DEVELOPMENT REVIEW BOARD REPORT

69-DR-2004
Mark Kia Auto Showroom & Service Center

REQUEST

Request approval of site plan & elevations for renovations and showroom addition to an existing building, and a new auto service center at the site.

S101

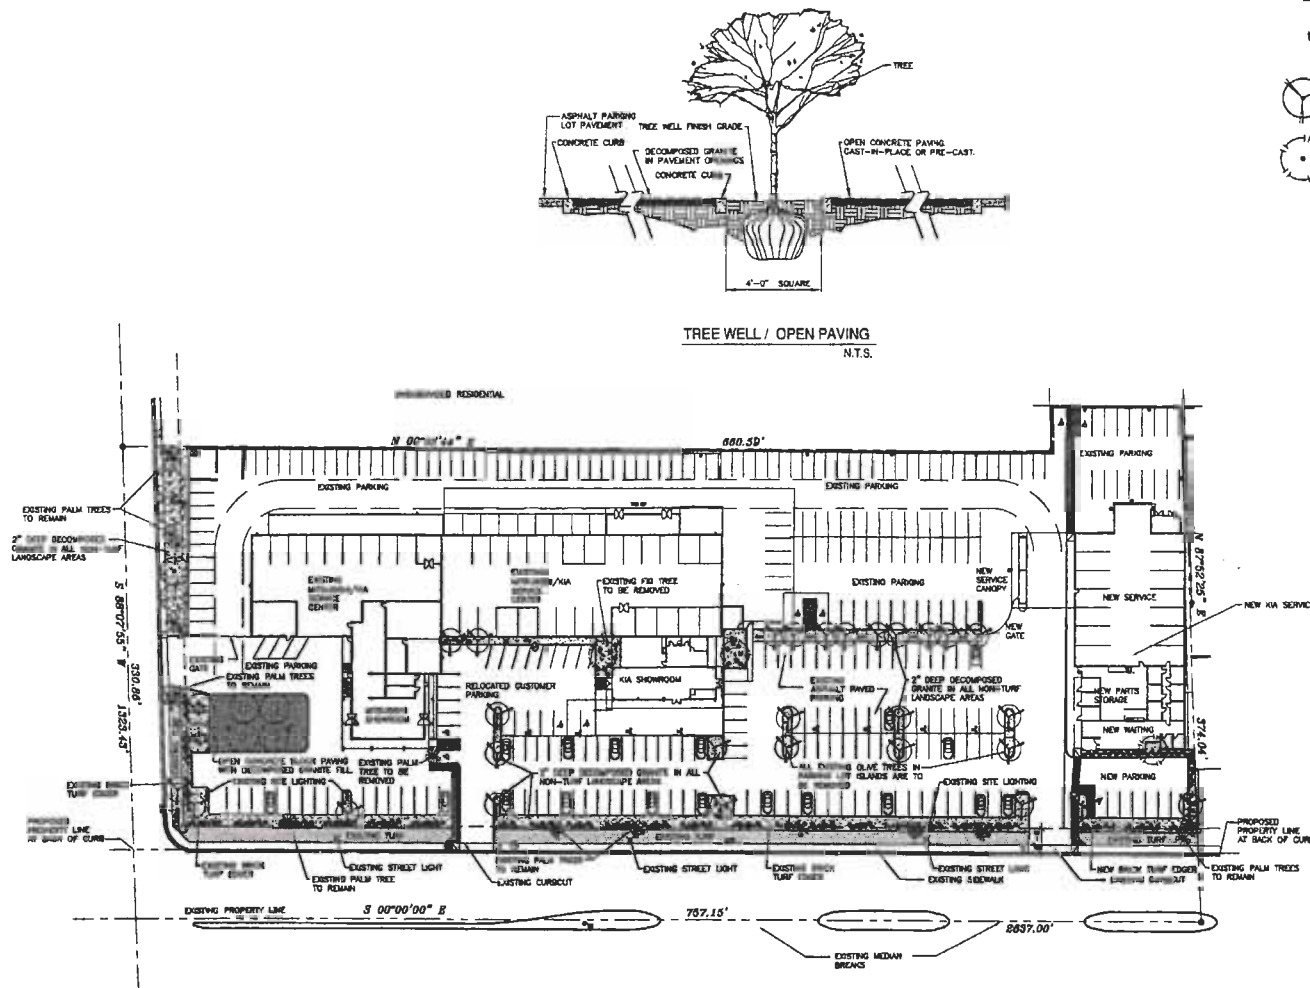
16. Prior to final plans submittal, the applicant shall submit a revised site plan showing revised open space areas and re-labeling parking areas by designation, subject to staff approval.

- b. Site improvements shall generally be consistent with the site plan Sheet S101 submitted by Marc Architecture with a plan date of 1-26-05.
 - c. Landscaping, including quantity, size, and location of materials shall be installed to be consistent with the conceptual landscape plan submitted by Terrano Landscape Architecture with a seal date of 12-22-04.
